Portland General Electric Company
Trojan Nuclear Plant
71760 Columbia River Hwy
Rainier, OR 97048
(503) 556-3713

VPN-004-2001

PGE-1061, "Trojan Nuclear Plant Decommissioning Plan
and License Termination Plan (PGE-1078)," Revision 9

SUMMARY OF CHANGES

Figure 2-10

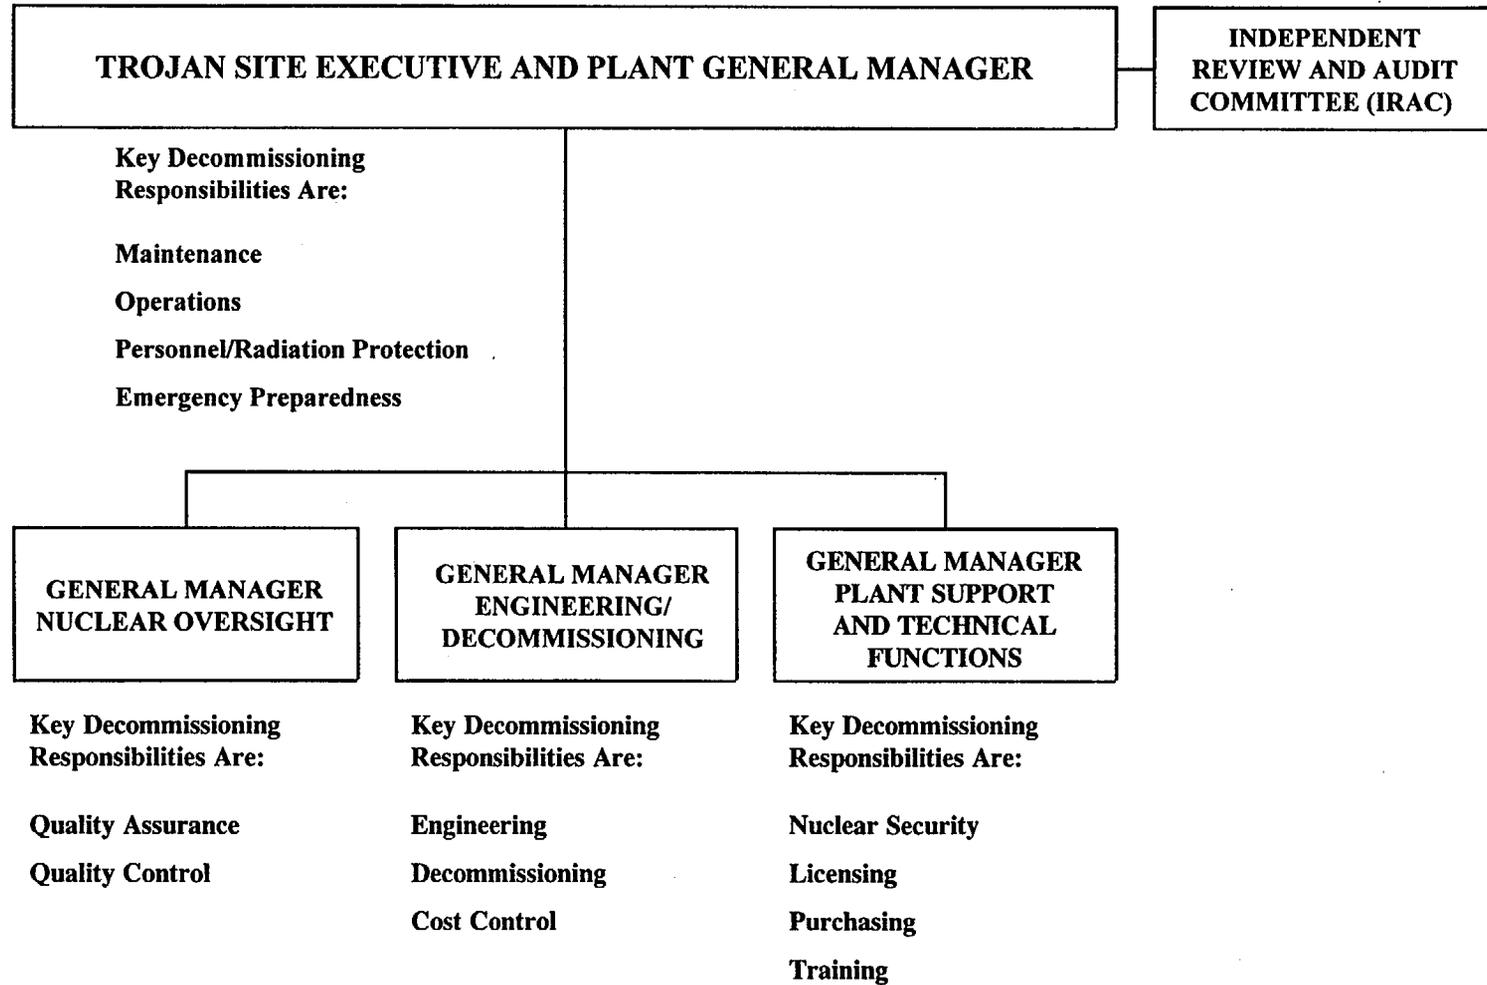
Administrative changes are made to former Section 2.3.1 and Figure 2-10 to indicate that the General Manager, Engineering/Decommissioning, is responsible for cost control.

Figure 2-11

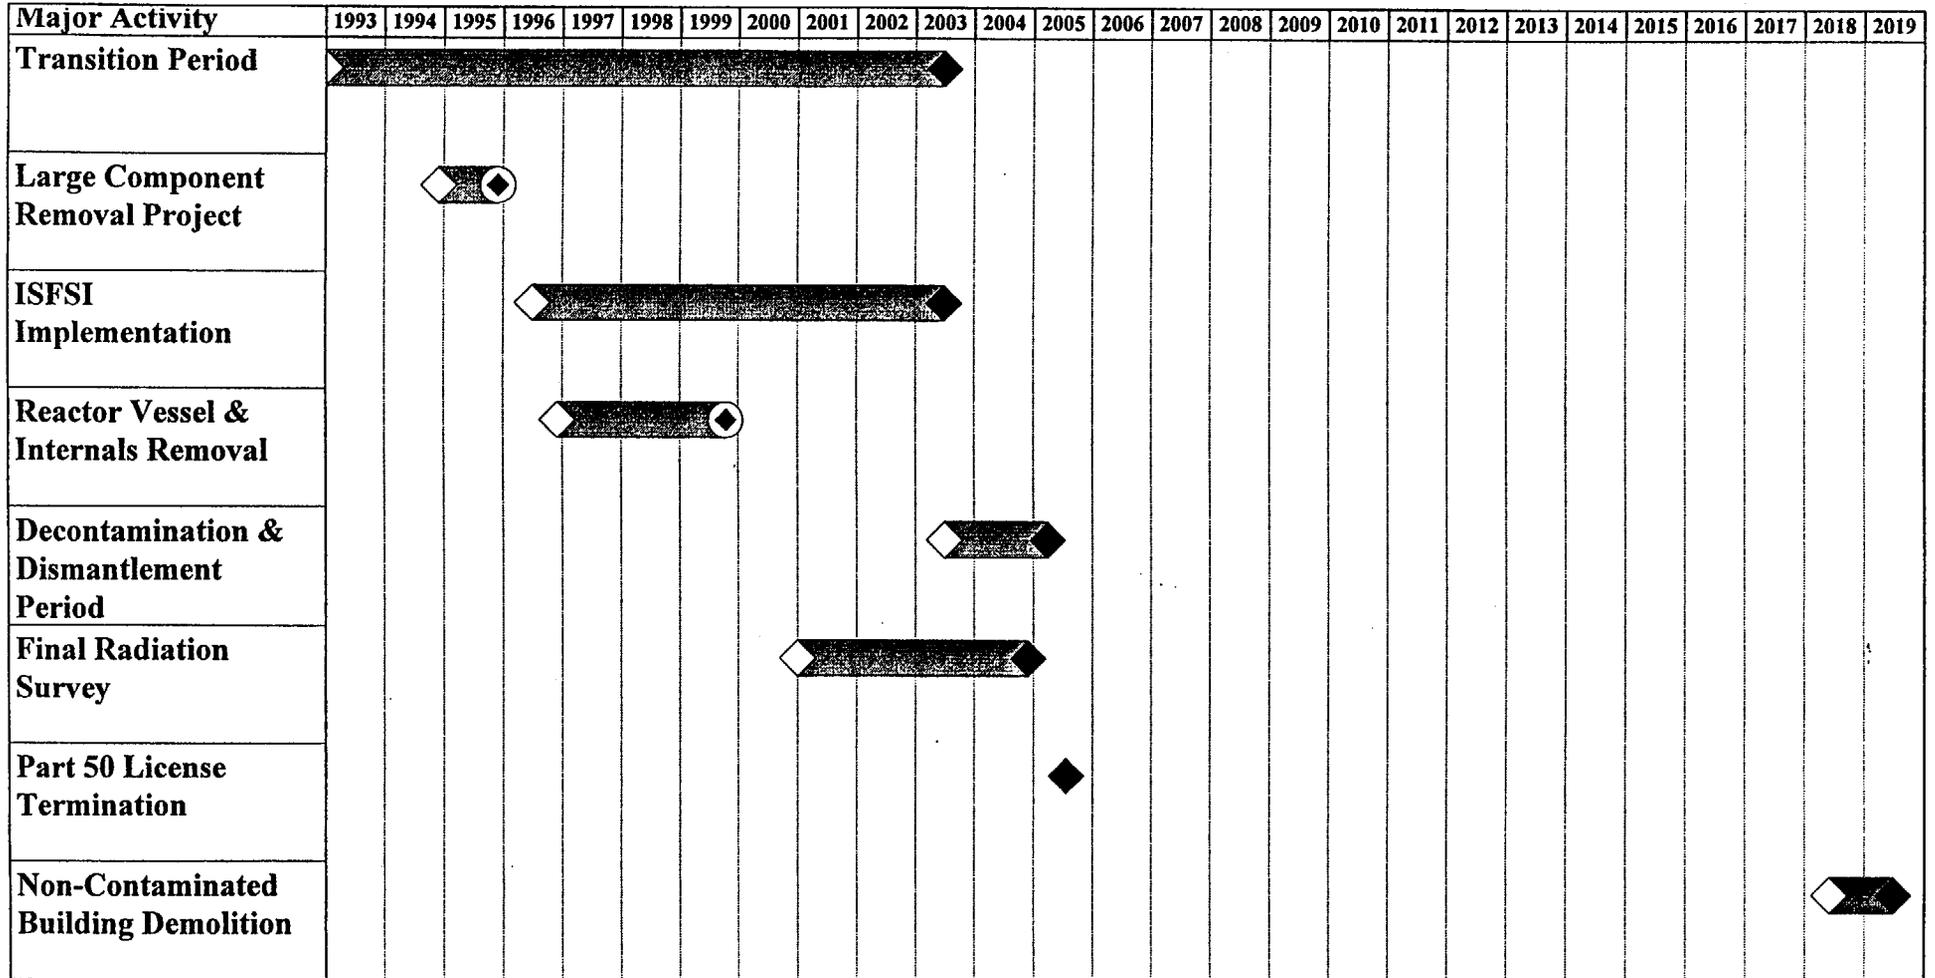
Sections 1.2.3, 2.2.2, and Figure 2-11 are revised to reflect the impact of delays in Independent Spent Fuel Storage Installation (ISFSI) design and fabrication activities on the decommissioning schedule.
